VRP Sixth Semi-Annual Progress Report  
(PR-6)

Metalplate Galvanizing Facility  
505 Selig Drive, SW  
Atlanta, Fulton County, Georgia 30336

HSI No. 10204

February 18, 2014

FIGURE NUMBER  
**1**

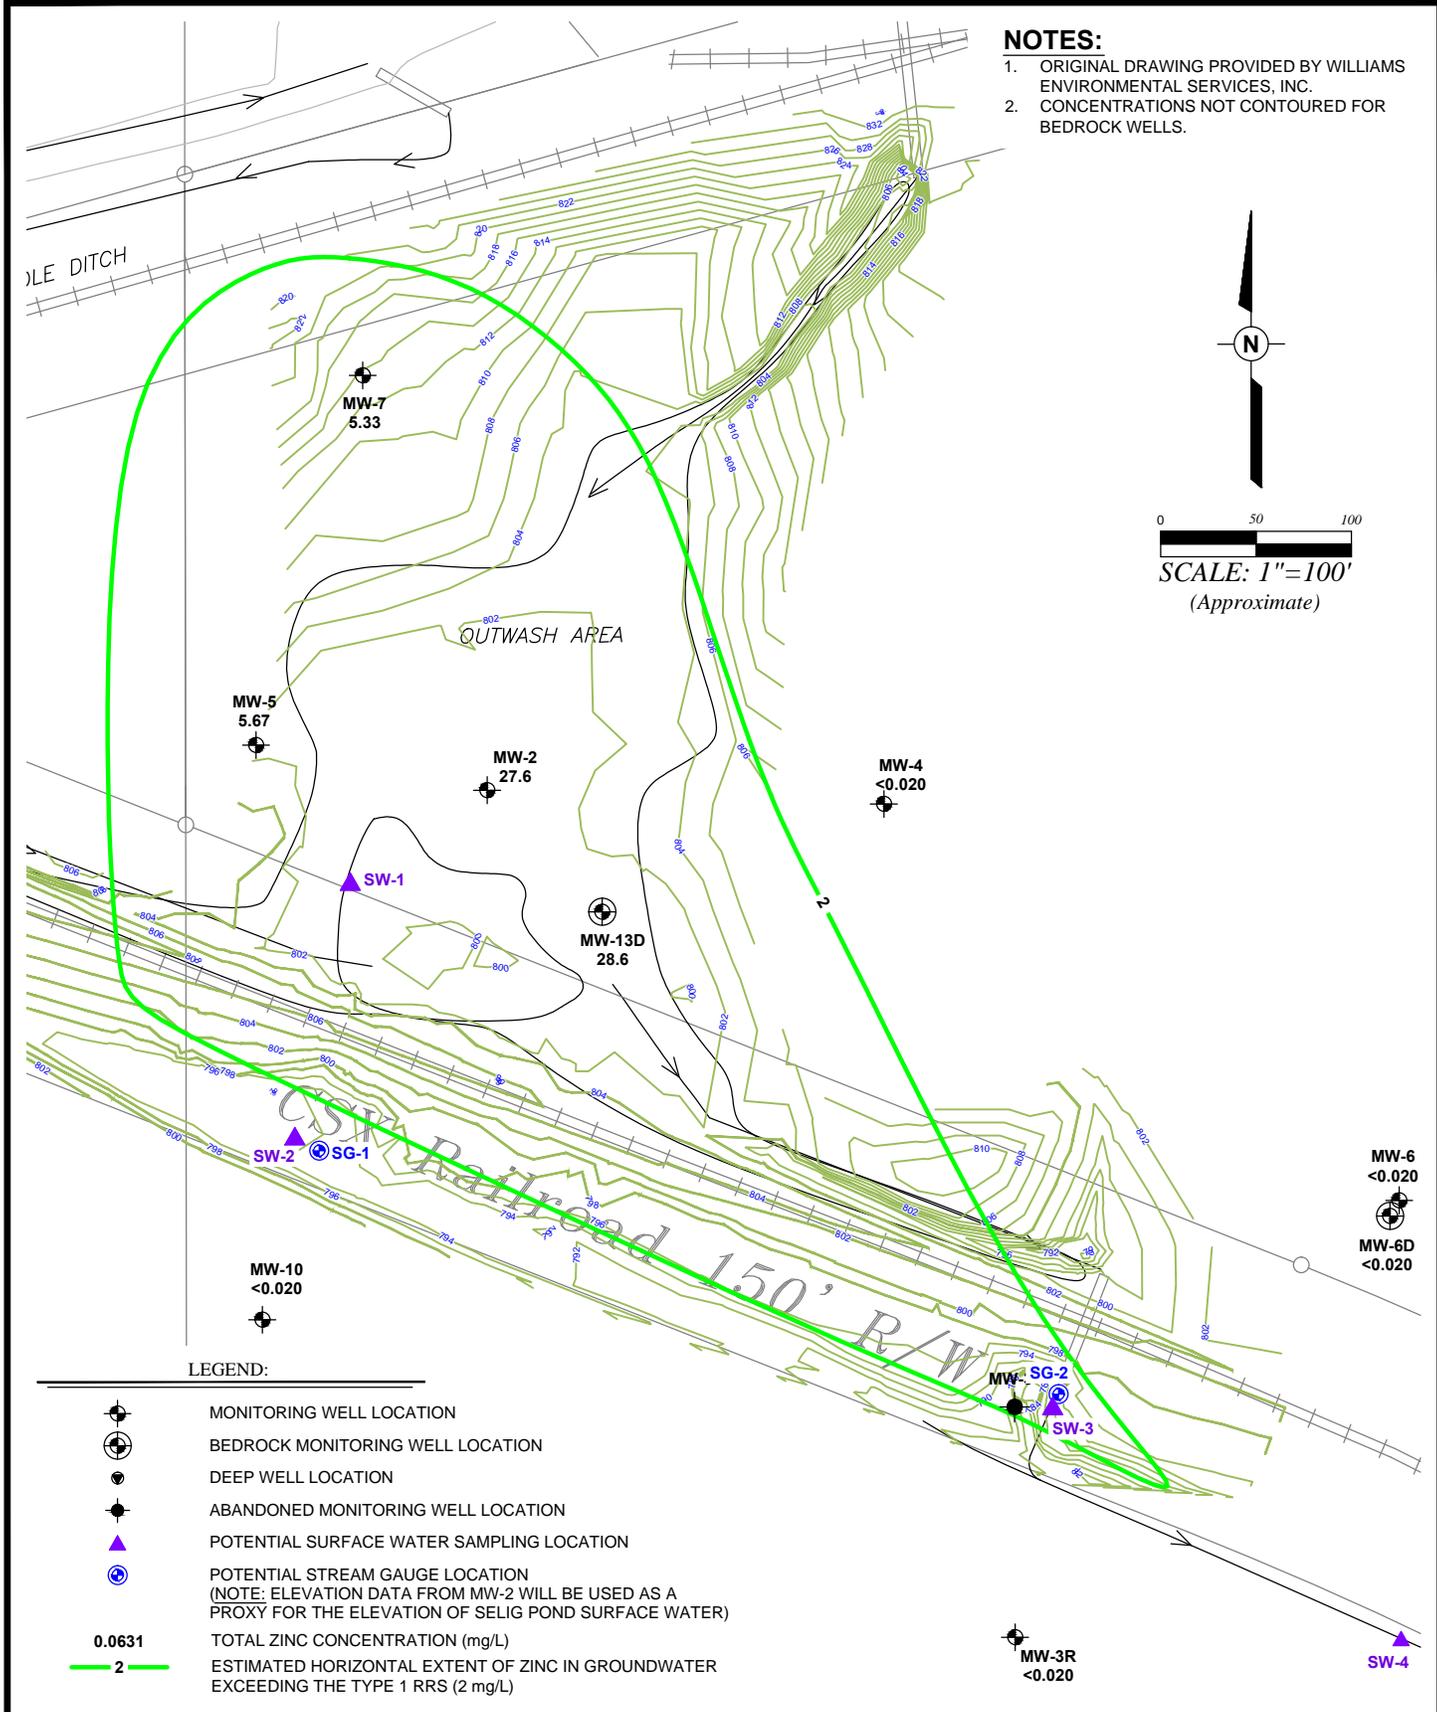
3. The interaction between surface water and groundwater would be better understood with the collection of comprehensive rounds of surface water and groundwater elevation data relative to mean sea level. This data should be plotted on a C size drawing incorporating all monitoring wells and surface water features in the vicinity of the Site. This has previously been requested in Comment 2 of EPD's February 14, 2011 VIRP comment letter and in Comment 1 of EPD's June 29, 2012 VIRP - First and Second Semi-Annual Progress Reports comment letter.

3. For water elevation data collection events, Metalplate proposes to collect data from monitoring wells 1, 2, 4, 5, 7, and 13D, as well as the staff gauge points approximately denoted on the attached Figure 1. Note that the listed monitoring wells are the same wells that would be subject to annual sampling under EPD comment 5. Metalplate also proposes to use elevation data from MW-2 as a proxy for the elevation of Selig Pond surface water because grounding a staff gauge in the Pond
